Public Utilities Commission of Nevada  
Electronic Filing

Re: **Sierra Club's Prepared Direct Testimony in Phase III of Docket No. 24-05041**

Joint Application of Nevada Power Company d/b/a ) Docket No. 24-05041  
NV Energy and Sierra Pacific Power Company d/b/a )  
NV Energy for approval of their 2025-2044 Triennial )  
Integrated Resource Plan and 2025-2027 Energy )  
Supply Plan. )

**Figure 3. NV Energy major projects new load (MW)**

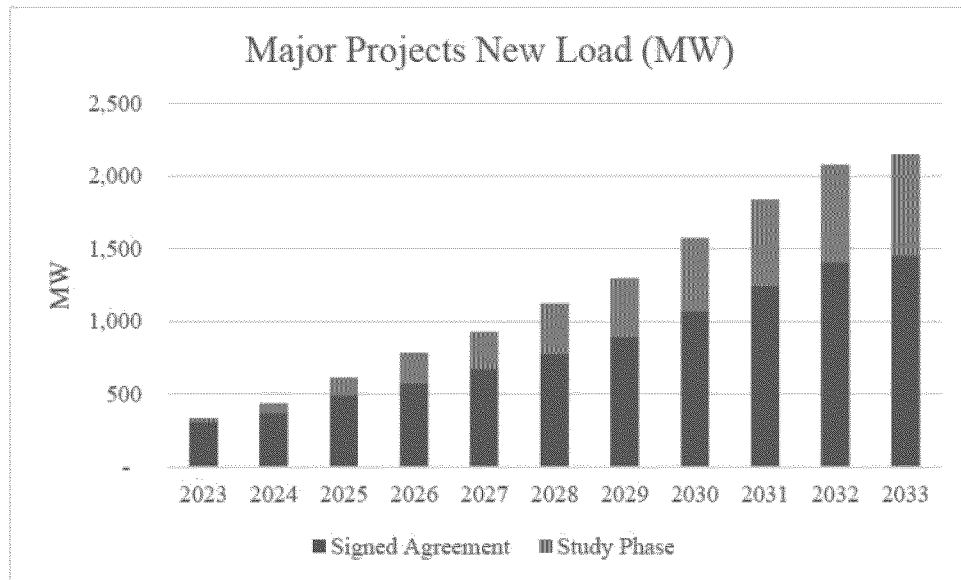
4 However, the larger bulk electric system risks do not appear to be mitigated by  
5 the Company’s abnormal risk agreements. The Company is planning on almost  
6 1000 MW of new peak load from large industrial customers by 2027 and over  
7 1500 MW by 2030.<sup>77</sup> This will require the Company to rapidly acquire new  
8 generation resources at a cost to customers, as shown by the installation of over  
9 10,000 MW of new installed capacity by 2035 in the Company’s preferred plan.<sup>78</sup>
